## Solicitation Addendum

Addendum No.:	1
Solicitation No.:	23-R081989DJ
Solicitation Title:	Manatee County Sheriff's Office Operations Center Chiller Plant Replacement
Addendum Date:	July 27, 2023
Procurement Contact:	Dave Janney Procurement Agent III

1 CHILLER DETAIL  
M4.0 NOT TO SCALE

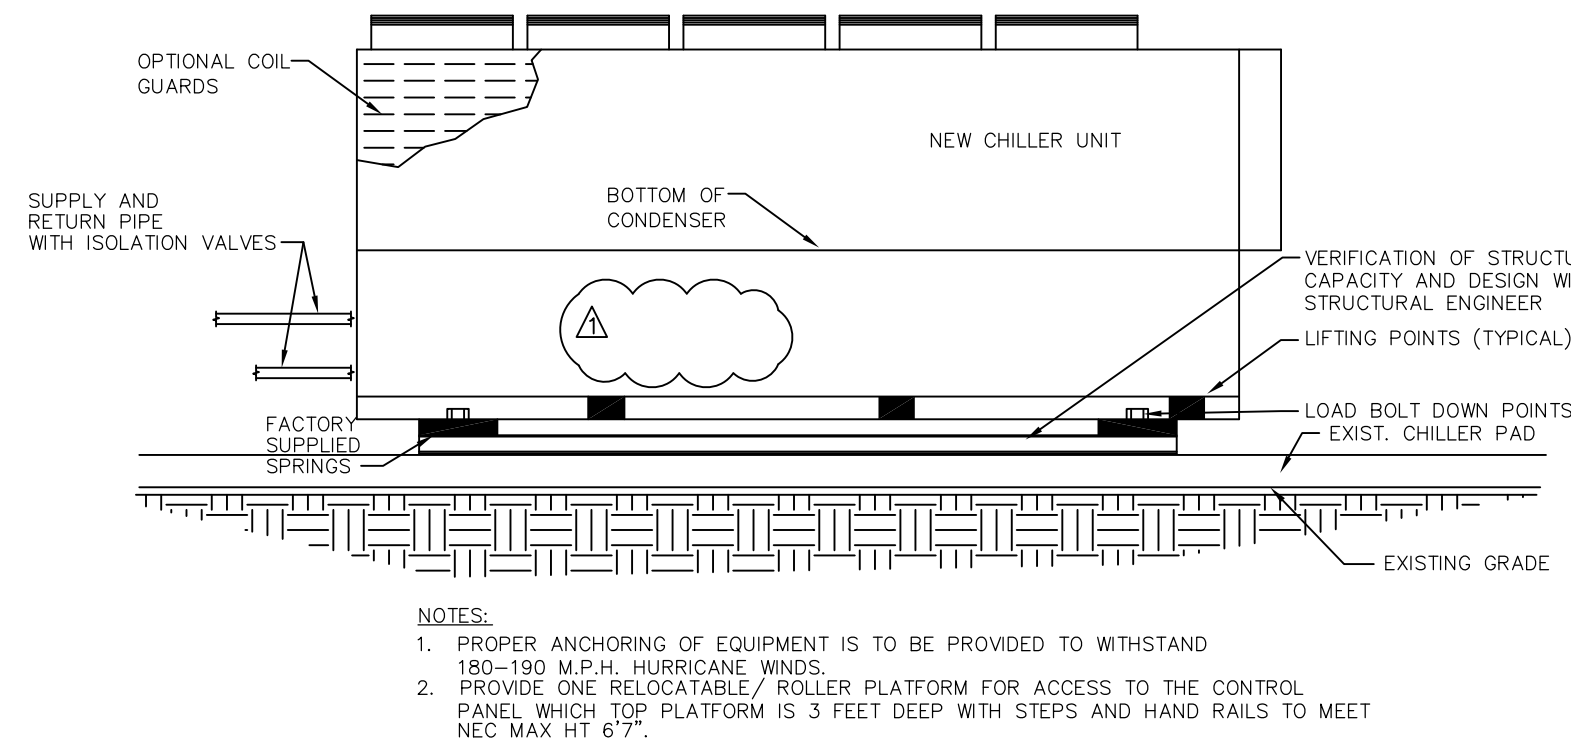
**Q10. Regarding detail 1 on page M4.0 note 2, I am not understanding what is required per this note. Do you want a rolling step to access both control panels because of the height of the control panels from the ground?**

**Q11. Regarding detail 1 on page M4.0 "verification of structural capacity and design with MC structural engineer". This is an existing pad. What is required to be included in our proposal? Do you want a structural engineer hired to look at the existing pad? Is there a new chiller pad required?**

**Q13. Regarding detail 1 on page M4.0 "see detail M3.0 for piping connection", I did not locate a detail 2 on page M3.0?**

R10. The rolling step is not required if there is an access panel for controls that is within the standing height range of a person (top of panel is 5').

R11. If the units are being replaced in kind no variations are required. If there are major changes in the size, then a structural analysis would need to be conducted by a structural engineer hired by the contractor.

R13. There is no detail on M3.0- the note is a typo. See attached M4.0 Mechanical Details – REV 1.

7 HOT WATER END SUCTION PUMP DETAIL  
M4.0 NOT TO SCALE

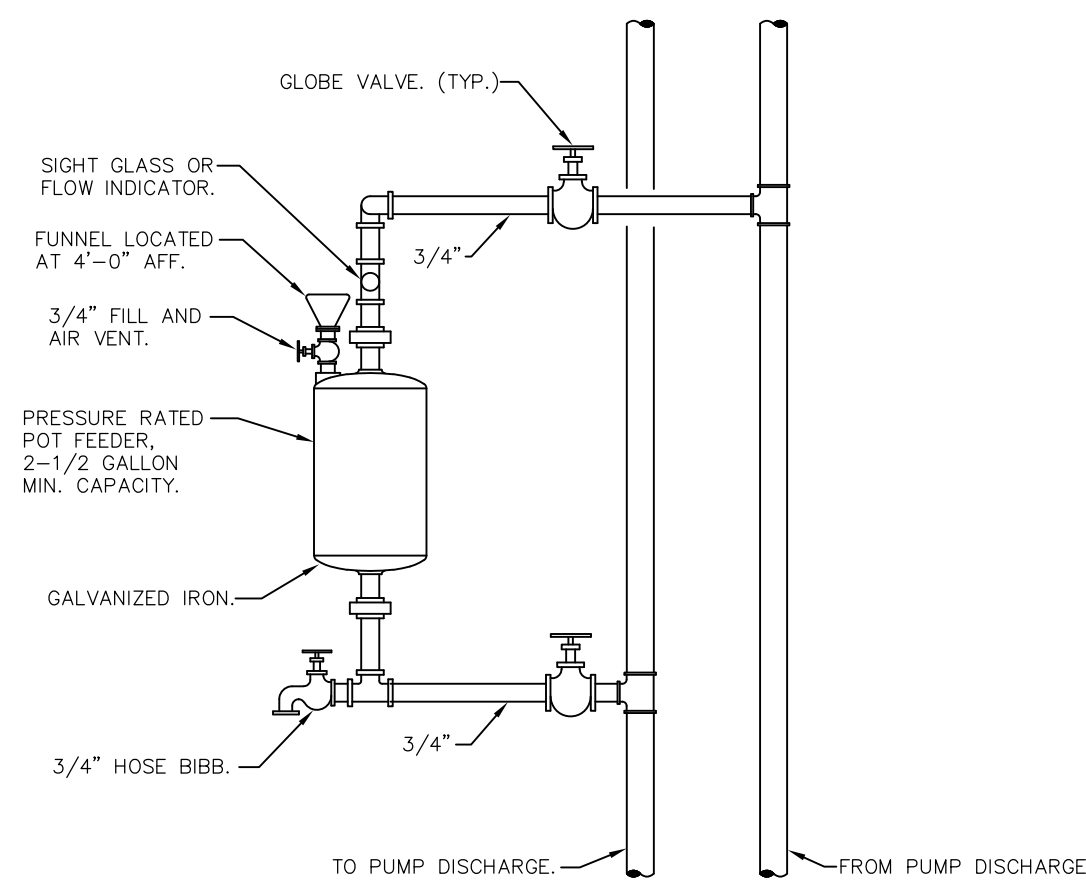
**Q12. Regarding detail 7 on page M4.0, The pumps are currently set on the concrete. Do you want new 4" pads poured on top of the existing pads? Are the new pumps to be bolted down to the existing (or new) pads?**

R12. Existing pads can be demolished and new pads can be installed. See housekeeping pad detail sheet E6.0 detail 8.

ELECTRICAL PROPOSED POWER AND SYSTEMS PLAN  
1/8" = 1'-0"

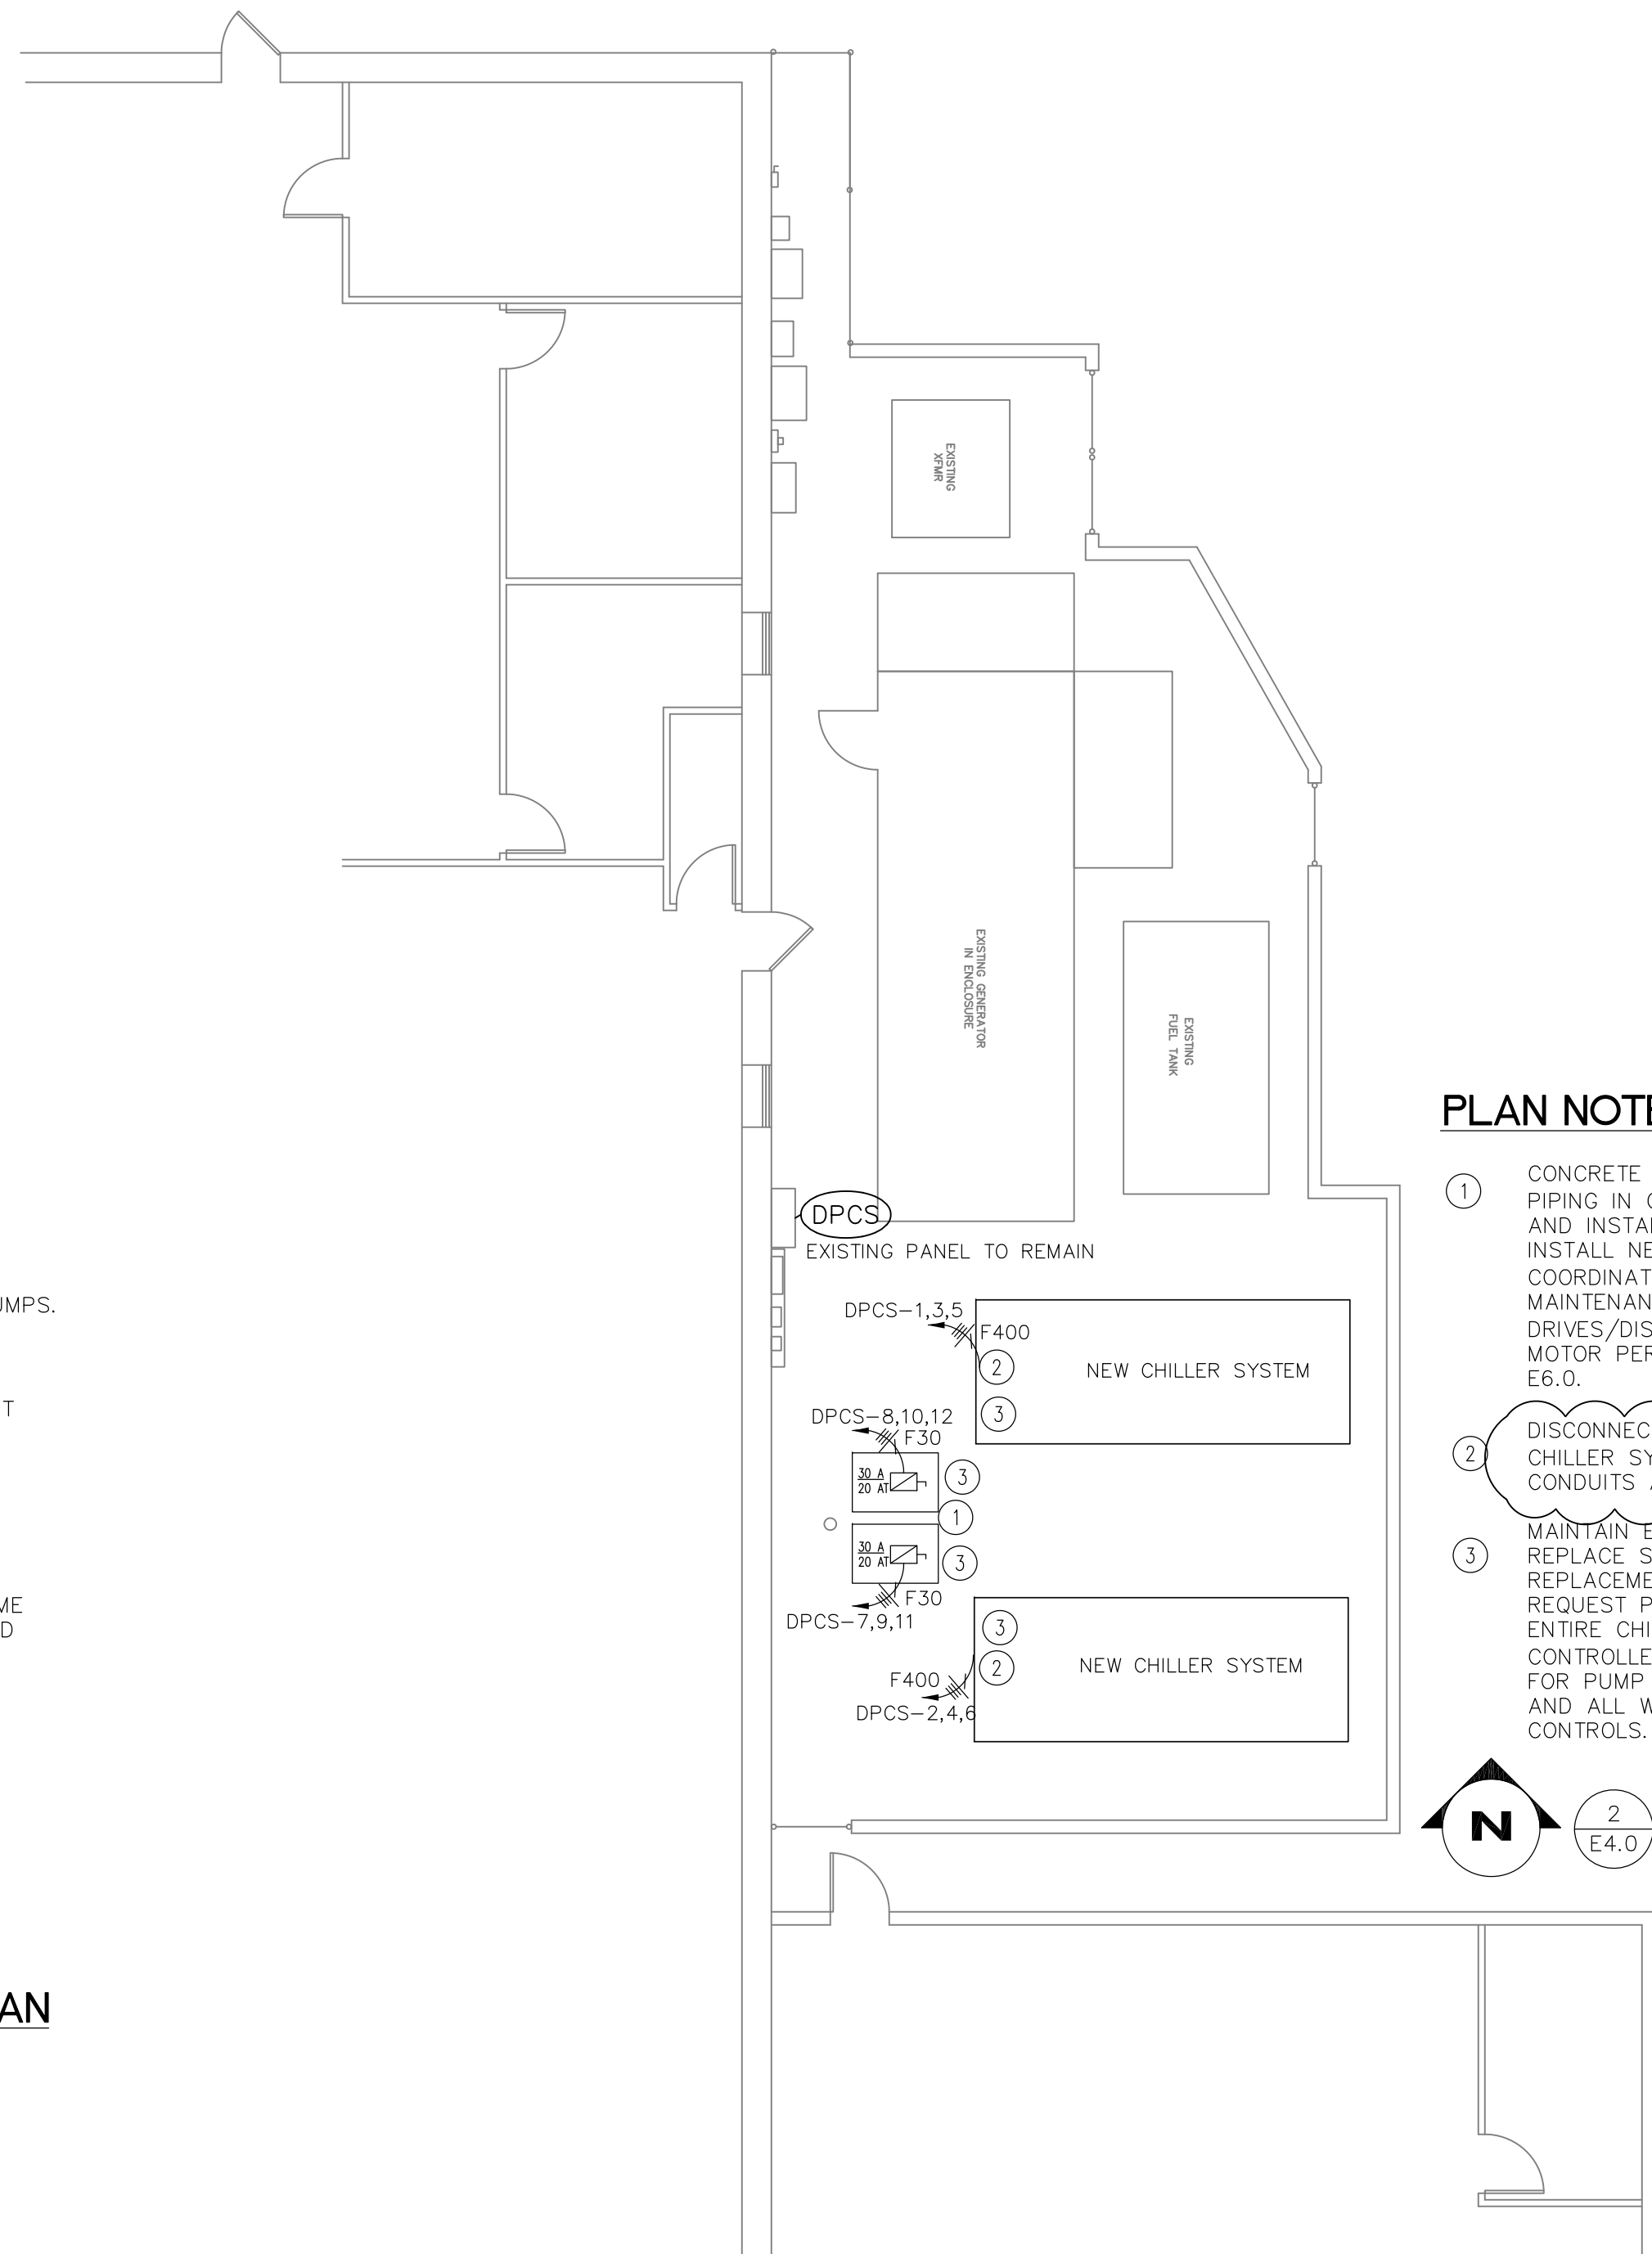
**Q21. On E4.0 demo note 2 remove existing chiller wiring from breaker but maintain existing conduit. Existing chiller breakers are 400amp 3pole breakers. The existing conduit is one 2" conduit per chiller. Not sure how this worked because even if you install parallel feeds in one conduit this conduit is too small.**

**On E4.0 proposed note 2 is to reuse existing conduit but on E5.0 one line diagram shows F400 which is parallel feeds that's 2 – 2 1/2" conduits to each chiller.**

**Do we cut slab and install correct conduits to each chiller or somehow go over head with the conduits?**

R21. Follow the chilled water lines to the building with support and go from the wall to the existing distribution panel for the power. The lines may be surface mounted and go overhead. The Successful Bidder to provide conduits for installation of chillers. See attached E4.0 Power and Systems Plan – REV 1.
